World Forum for Harmonization of Vehicle Regulations

1958 Agreement – Consideration of draft amendments to existing Regulations submitted by GRE

Proposal for Supplement 8 to Regulation No. 65 (Special warning lamps)

Submitted by the Working Party on Lighting and Light-Signalling *

"Annex 2

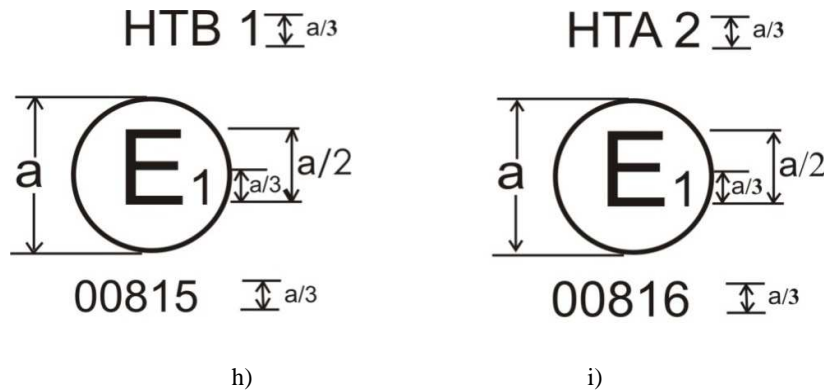
Annex 2, insert new examples of approval marks h) and i), to read:

- h) A half bar of a special warning lamp indicates that it has been approved in Germany (E1) under approval number 00815. The approval number shows that the approval was granted in accordance with the requirements of the Regulation in its original form and that it is a blue rotating or stationary flashing special warning lamp of class 1 (HTB 1).
- i) A half bar of a special warning lamp indicates that it has been approved in Germany (E1) under approval number 00816. The approval number shows that the approval was granted in accordance with the requirements of the Regulation in its original form and that it is a amber rotating or stationary flashing special warning lamp of class 2 (HTA 2)."
